**PLANNED UNIT DEVELOPMENT
& SUBDIVISION STAFF REPORT****Date: May 15, 2008**

DEVELOPMENT NAME Baldwin Transfer Subdivision

LOCATION 1501 Telegraph Road
(Northwest corner of Telegraph Road and Callahan Drive)

CONTEMPLATED USE Planned Unit Development Approval to allow two buildings on a single building site, and Subdivision approval to create one (1) lot.

SITE PLAN

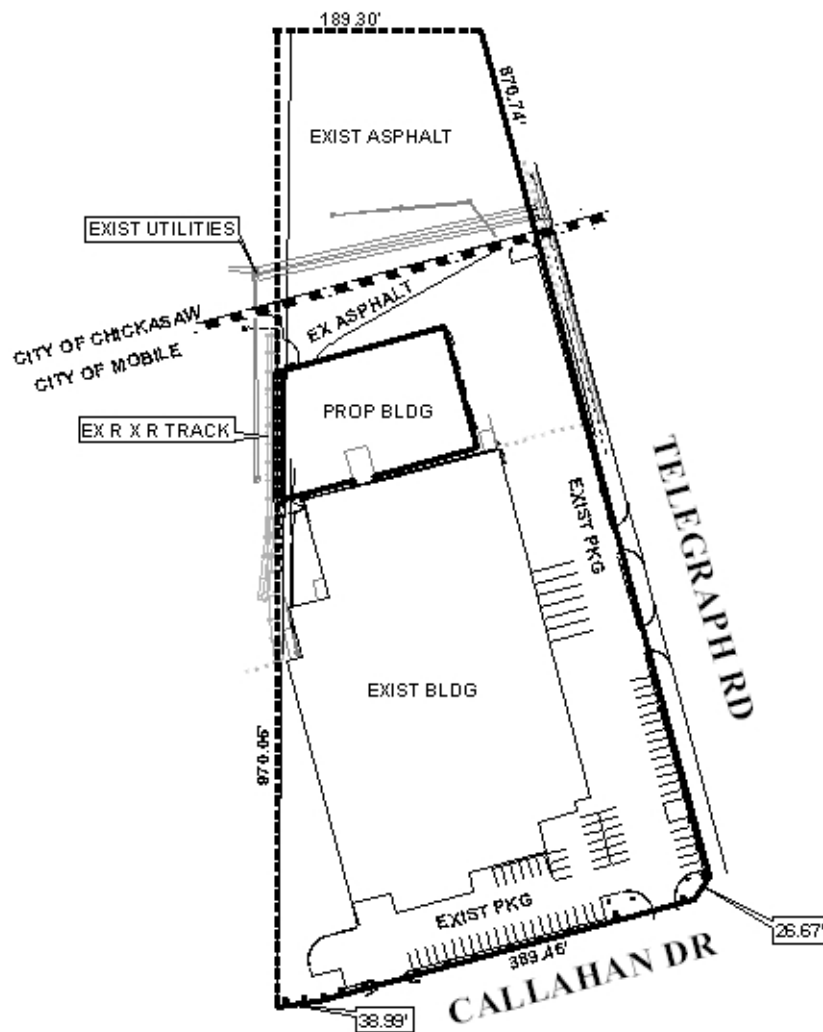
The site plan depicts proposed frontage trees, as required in I-2 areas, and landscape areas and calculations. As provided on the site plan, the site is deficient in overall landscape area and in required front landscape area, however, the proposed addition will not exceed the 50% threshold that triggers full compliance with the landscape requirements of the Zoning Ordinance, although

Regarding parking, warehouse uses are required to provide parking at a ratio of 1 space per 300 square feet of office use, and 1 space per 3 warehouse employees. The site plan indicates that 63 parking spaces are provided, but no overall employee numbers for the site are provided, nor is any information regarding the amount of office space provided. While the site likely provides adequate parking overall, the site plan should provide complete information for the overall site.

As the site is a warehouse facility, tractor-trailer movements to and from loading docks will occur. All loading docks should be depicted on the site plan, and basic loading dock maneuvering and tractor-trailer parking areas depicted.

No dumpster is depicted on the site plan, however, some dumpster facilities may exist (according to aerial photographs). All existing and proposed dumpsters should be depicted on the site plan.

- 1) Revision of the site plan to reflect the total parking requirements based upon office area within the existing building, and the total number of warehouse employees, and provision of additional parking spaces if necessary to meet the minimum parking requirements;

- 2) Revision of the site plan to depict and label a 45-foot minimum building setback line from Telegraph Road, and a 25-foot setback line from Callahan Drive;

- 3) Revision of the site plan to depict and label existing and proposed dumpsters;
- 4) Revision of the site plan to depict all loading docks, tractor-trailer parking areas, and general tractor-trailer circulation;

- 5) Deannexation from Chickasaw and annexation into Mobile must be complete prior to issuance of Certificate of Occupancy;
- 6) Placement of a note on the site plan stating that the site is limited to the two existing curb-cuts onto Callahan Drive, and the two existing curb-cuts onto Telegraph Road, with any modifications to the curb-cuts in terms of size and location (not exceeding increases or changes of location greater than 5 feet) to be approved by Traffic Engineering and ALDOT, and to be in conformance with AASHTO standards: changes greater than 5 feet may require a new PUD application;
